Revised Bid Attachment 6, Addendum 4

CLIENT: MANATEE BOARD OF COUNTY COMMISSIONERS
PROJECT: WASHINGTON PARK PRESERVE PHASE I

DATE: JANUARY 2021
TITLE: SOD, SEED & MULCH EXHIBIT
INDEX NUMBER:
SHEET NUMBER: X-01

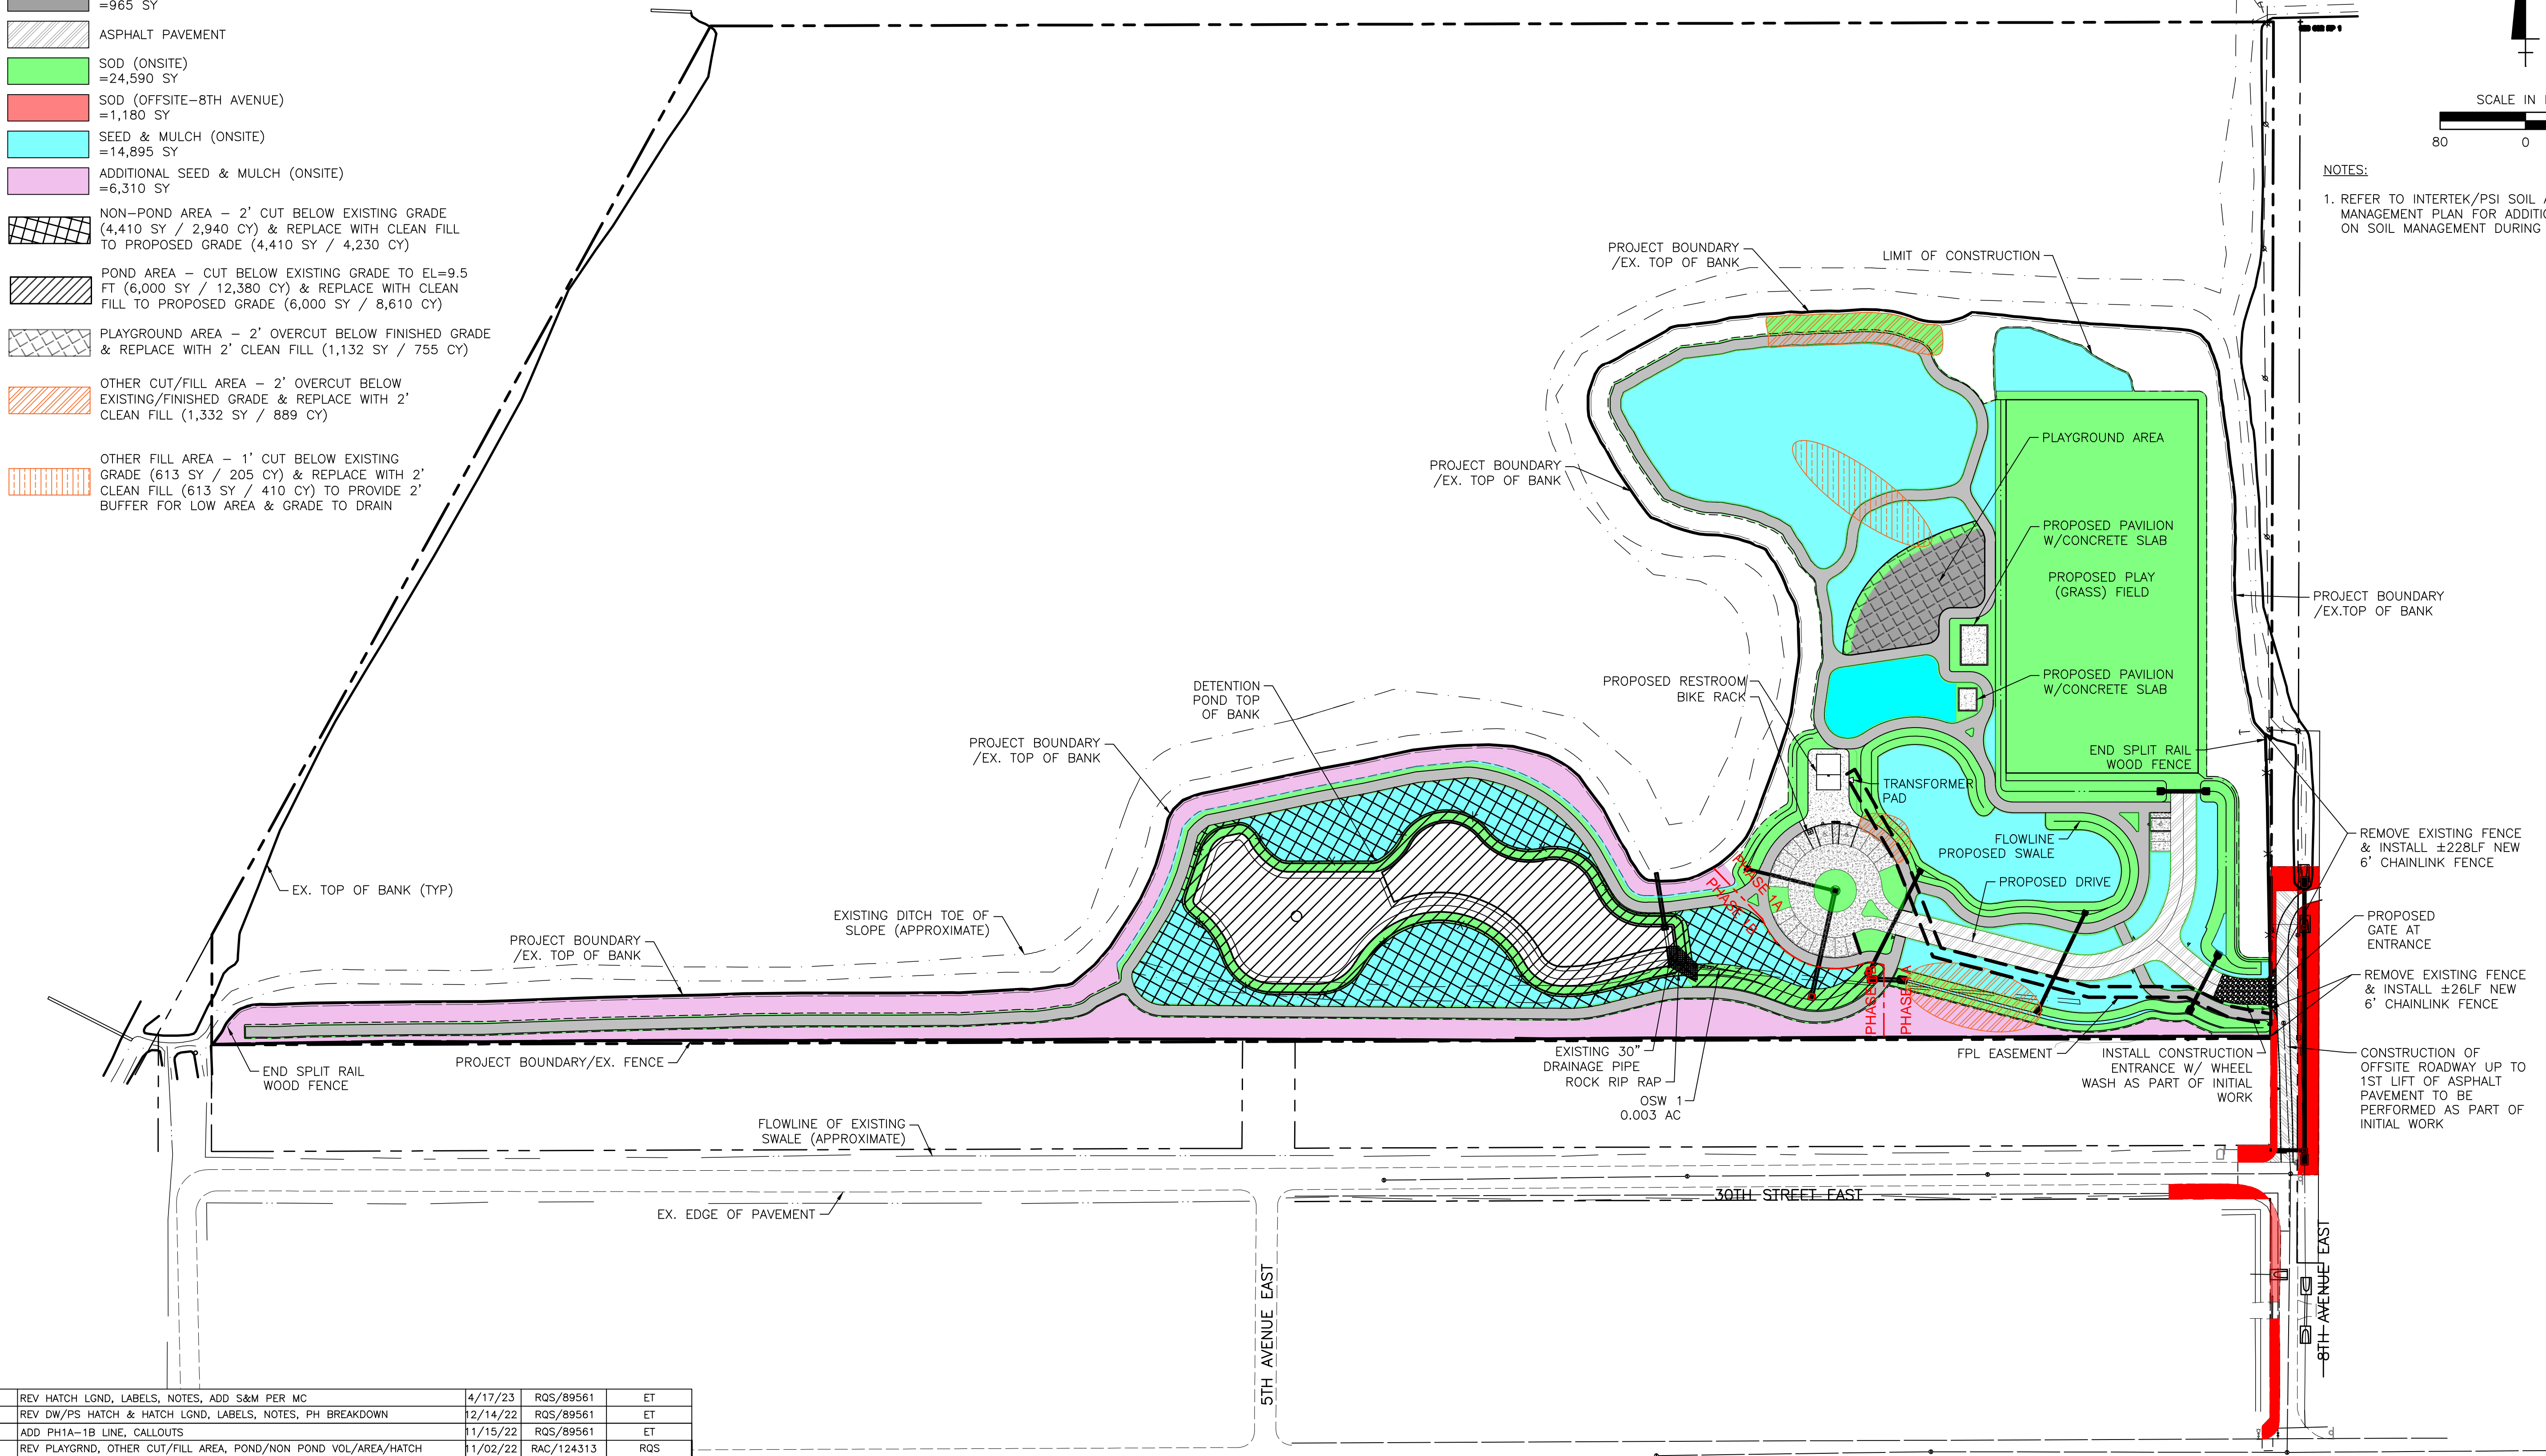
REV NO.	REVISION	DATE	DRAWN BY / EMP. NO.	CHECKED BY / EMP. NO.	WM APPROVED BY:
9	REV HATCH LGND, LABELS, NOTES, ADD S&M PER MC	4/17/23	RQS/89561	ET	
8	REV DW/PS HATCH & HATCH LGND, LABELS, NOTES, PH BREAKDOWN	12/14/22	RQS/89561	ET	
7	ADD PH1A-1B LINE, CALLOUTS	11/15/22	RQS/89561	ET	
6	REV PLAYGRND, OTHER CUT/FILL AREA, POND/NON POND VOL/AREA/HATCH	11/02/22	RAC/124313	RQS	
5	REV RR/SW LOCATION, ADD TRANSFORMER PAD, SOD, FPL EASEMENT	6/21/22	RQS/89561	ET	
4	REV SMP HATCH AREA/VOL, SOD AREA & ADD OTHER SMP HATCH PER MC REVS	4/4/22	RQS/89561	EA	
3	REVISE SOIL MGMT HATCH AREAS/VOL PER MC REVS	2/14/22	RQS/89561	EA	
2	REVISE 3 RAIL WOOD FENCE LOC. PER MC REVS	12/15/21	RQS/89561	EA	
2	ADD SW PROJ AREA SOIL MNGMT HATCH AREAS/VOL PER MC REVS	12/15/21	RQS/89561	EA	
1	REVISE SOD AREA	4/19/21	RQS/89561	EA	
1	REVISE ONSITE SEED/MULCH AREA	4/14/21	RQS/89561	EA
